**RE: Response to Preliminary Adequacy Review, 112c Construction Materials Permit Application
Section 25 Sand Mine, Permit No. M-2025-015**

This letter addresses the *Adequacy Review* letter dated June 4th, 2025 regarding the Section 25 Gravel Mine 112 Construction Materials Reclamation Permit Application Package. Responses to the Division's comments follow in **bold**:

70 RANCH SECTION 25
PROPPANT MINE
WELD COUNTY, COLORADO

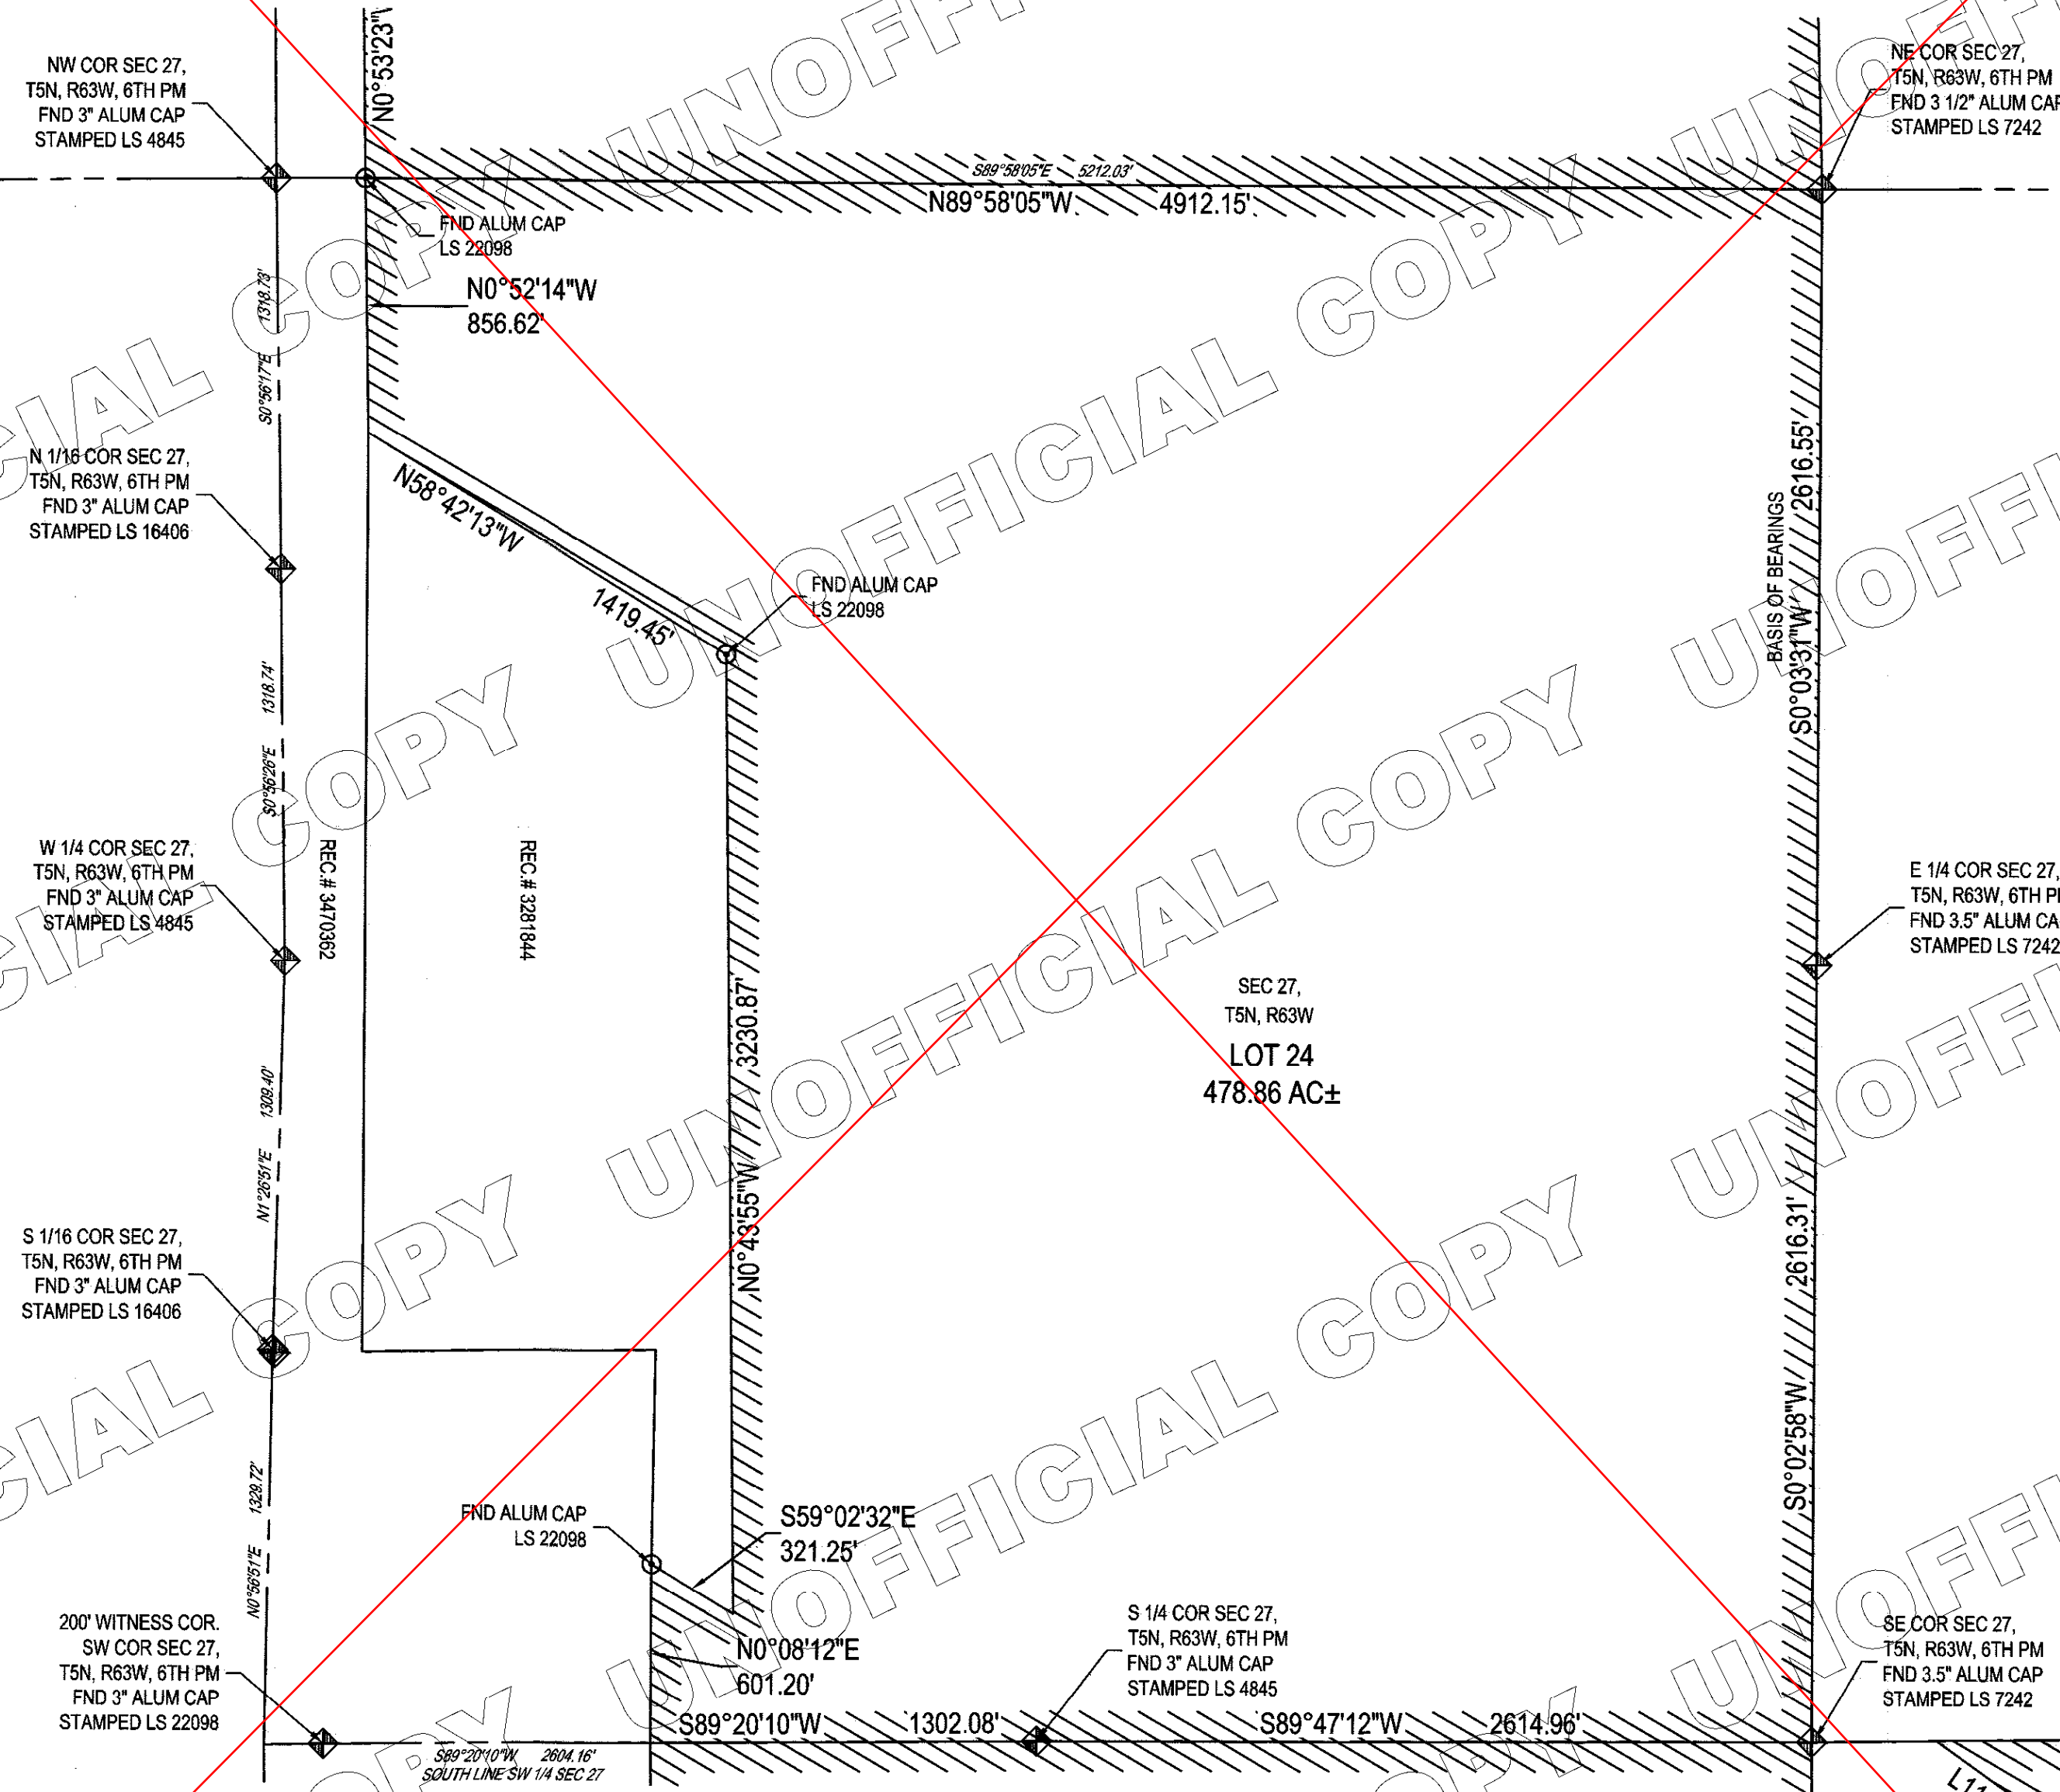
1. On Map C-1 please provide a table or clearly indicate on the map the coordinates, in decimal degrees, of the four corners of the permit boundary.

See attached survey plat showing the surveyed location of the four corners of the permit boundary.

RECLAMATION
PLAN MAP

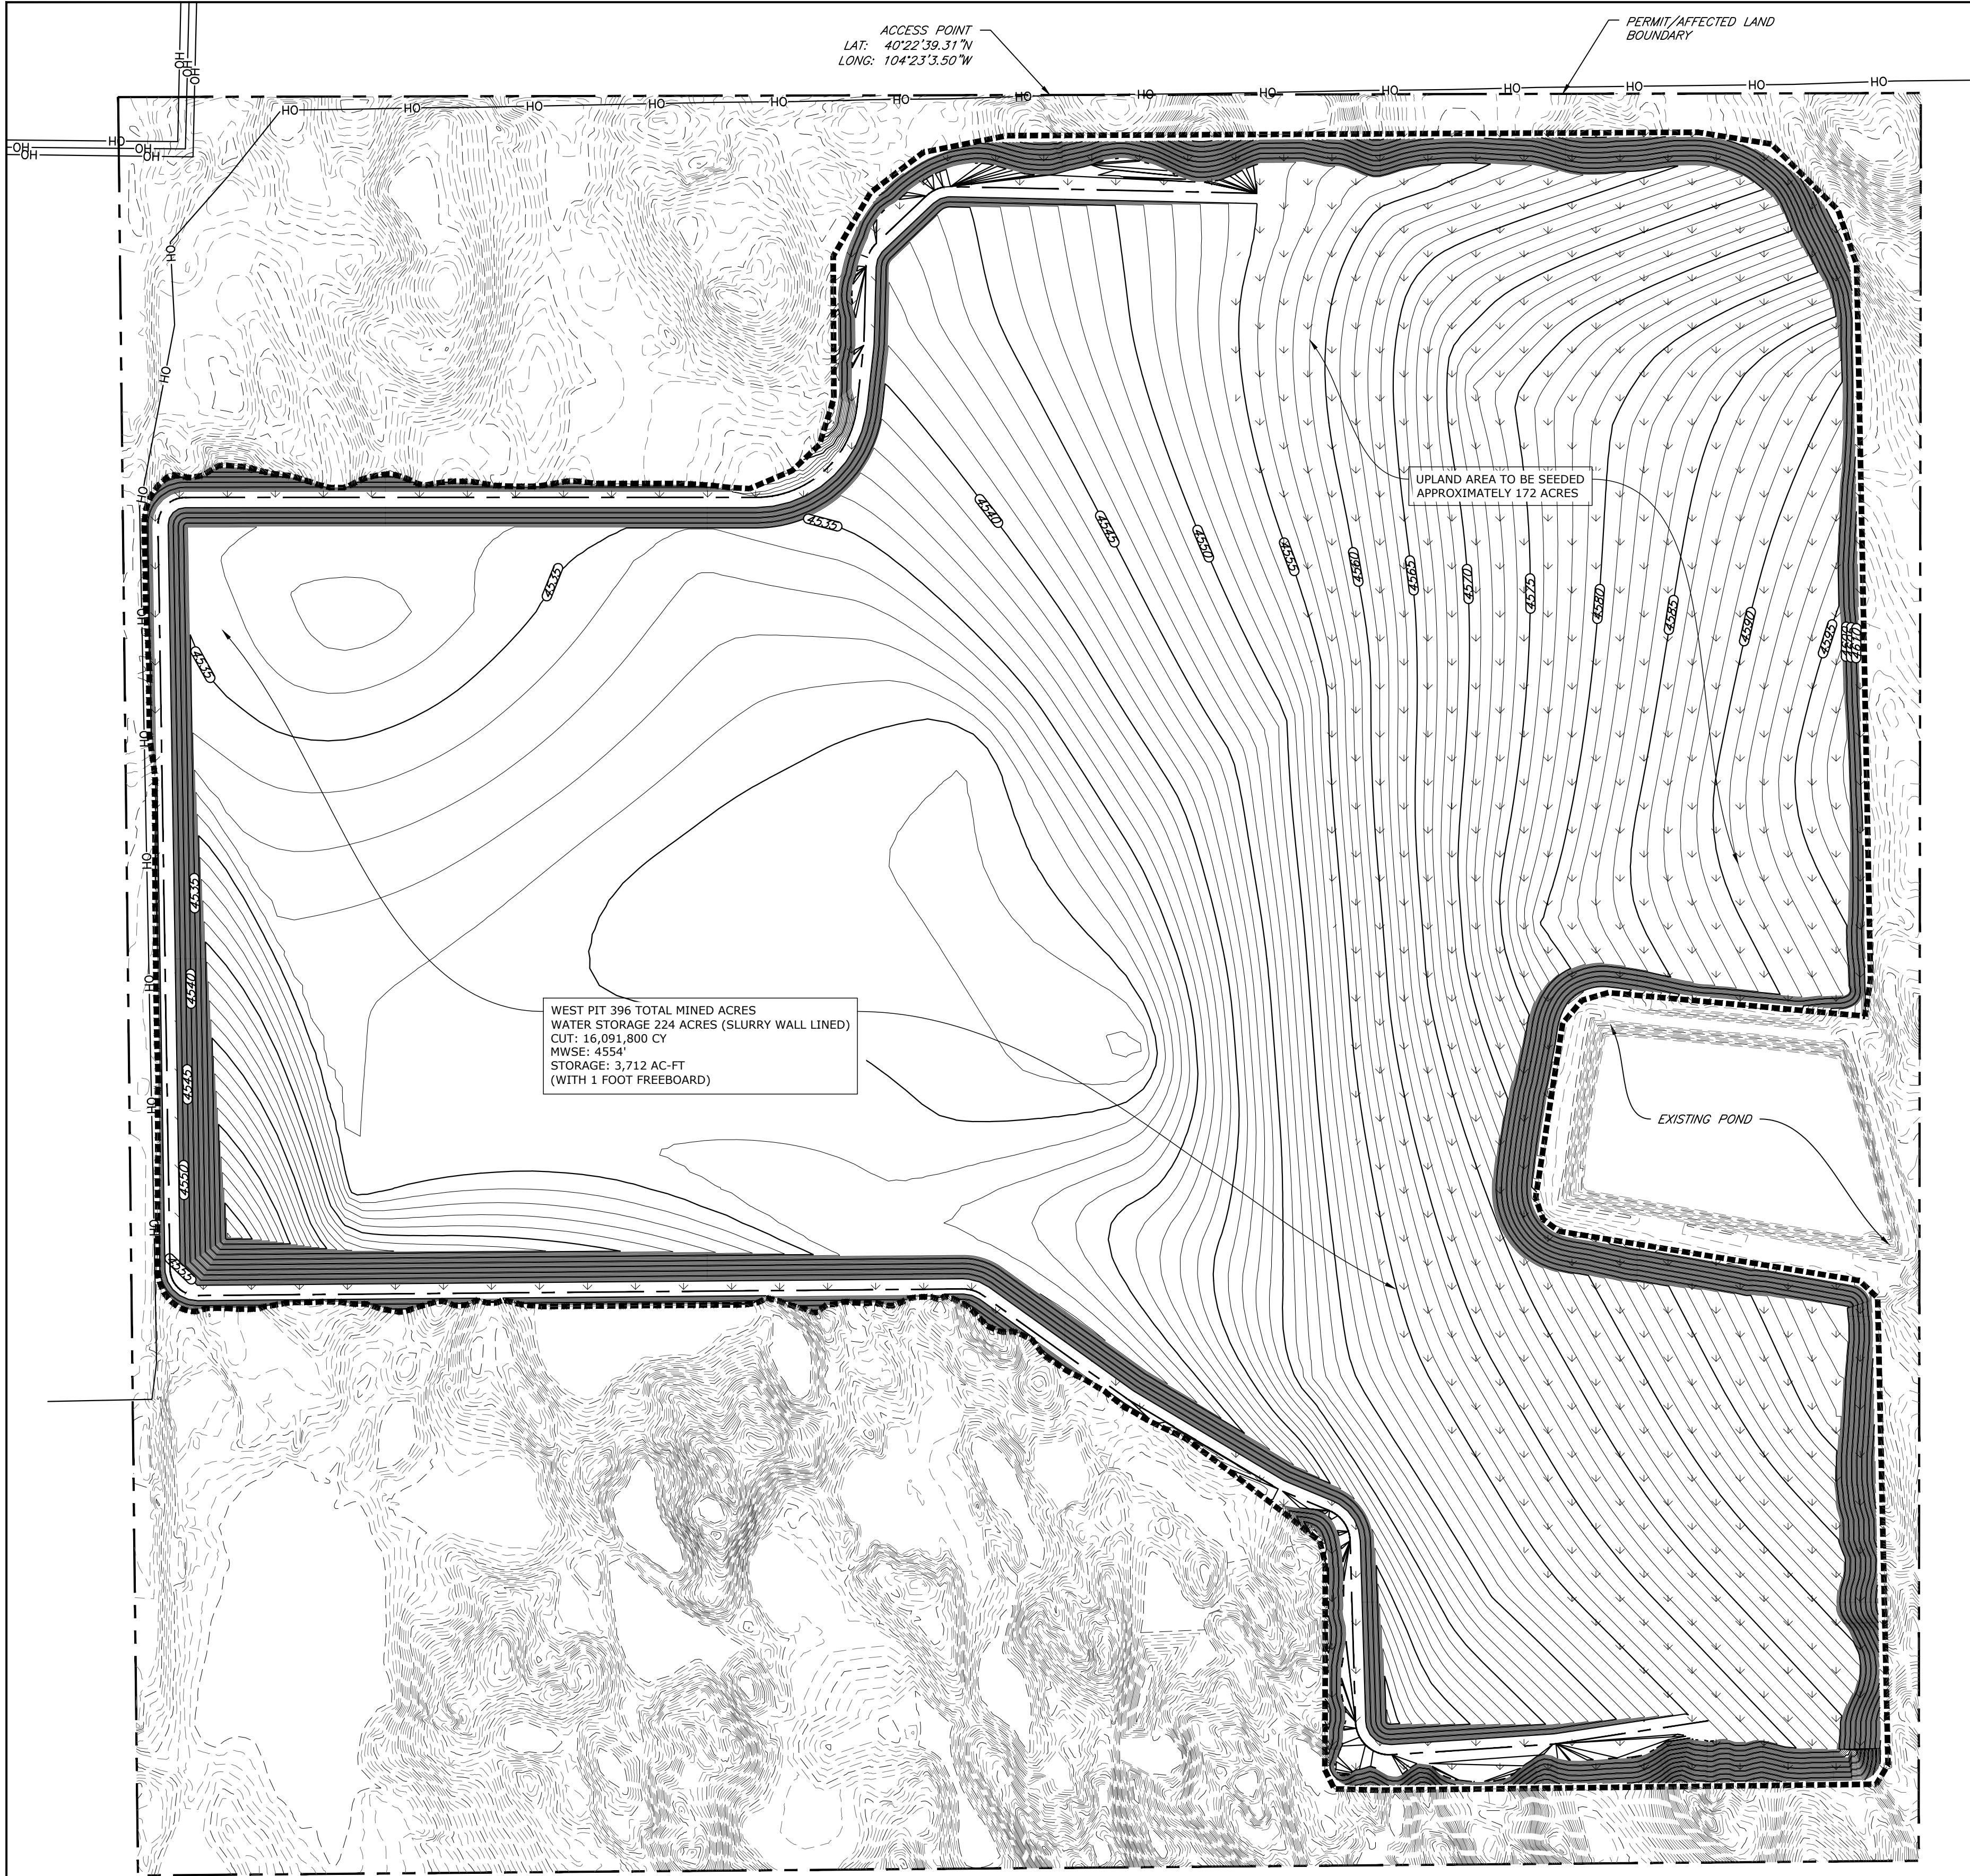
7. In the reclamation plan and on Map F-1 clearly indicate the area, in acres, to be revegetated.

The disturbed areas one foot above the maximum water surface of the pond will be revegetated with the seed mix indicated. The hatch sizing has been increased on map F-1 to provide more clarity on reseeded areas.
